October 29, 2024

**Re: Response to Technical Comments – SPC Application D07-12-24-0087; 2900 Brian Coburn Blvd./119 Ryan Reynolds Way**

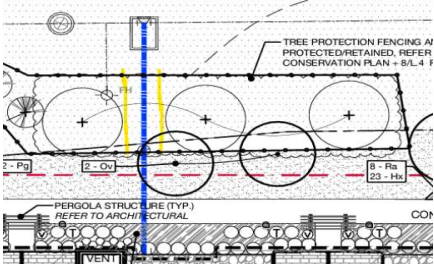
13. Section 4.4 Access Design:

Restricting the proposed Brian Coburn Boulevard access to right-in / right-out (as identified in the 2021 TIA) is supported. However, the use of a 'pork chop' island results in large access corner radii, which supports high turning speeds in and out of the access and could be hazardous to future pedestrian and cycling facilities on the south side of Brian Coburn Boulevard. It is therefore recommended that the access be restricted to right-in / right-out by extending the existing median on Brian Coburn Boulevard further east, across the access. The 'pork chop' island can then be removed from the design and the access radii reduced. The reduction in corner radii may also allow the development to meet the TAC Geometric Design Guide recommendations for access clear throat length.

The proposed pork chop island has been shown on the Site Plan for several submissions through the pre-consultation process and has not been commented on to date. While the proposed pork chop island has a large radius, the channelization and narrow access throat width within the site (6.7m) will assist in reducing vehicle speeds. Further, the MUP can be designed at the back of the ROW where vehicles entering the site will have clear sight lines and the ability to stop off-road within the pork chop area. No changes to the pork chop design are proposed as part of this application.

A new median along Brian Coburn Boulevard would require RMA approval and is anticipated to result in significant additional costs to the proponent compared to the previously proposed pork chop island. As the new median is being requested due to the MUP extension project, if pursued by the City, the costs associated with the design and construction of a new median should be funded by the City as part of the MUP extension project.
